890/897 Family Lube Hose Changes

JUMP-OFF SERIAL NUMBER : 6053** Production starting February 22, 2016**

897/899 LUBE FITTING CHANGE

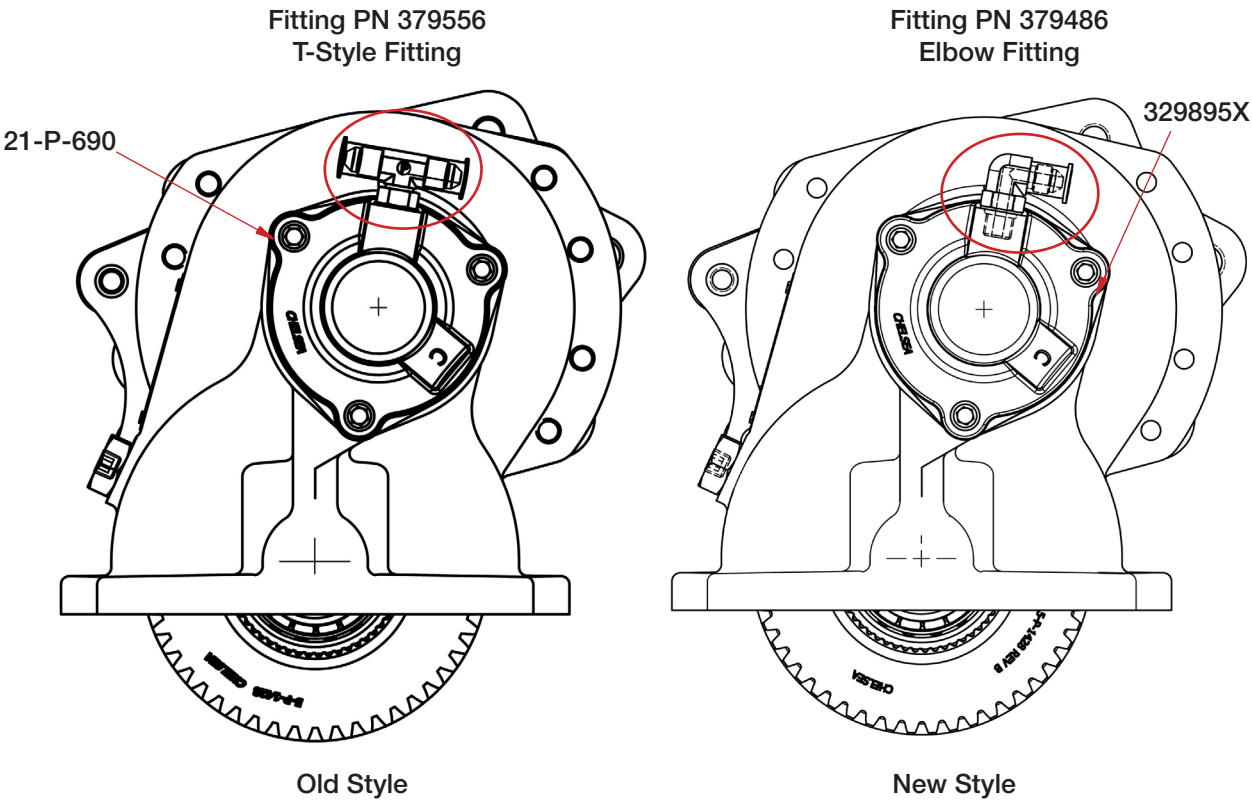
The installation of the 897 and 899 just got easier. These two series will no longer require the external lube hose for Wet Spline lubrication. A new seal cap design allows the metering of oil flow through the output shaft to provide positive lubrication to both the output bearing and Wet Spline outputs.

897/899 WET SPLINE LUBE HOSE REMOVED

897/899 SEAL CAP CHANGE

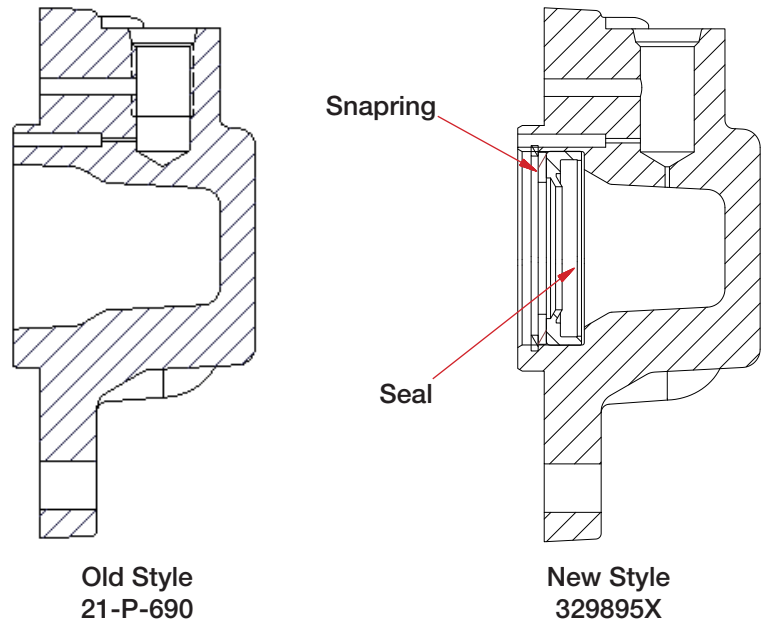
Seal Cap Change
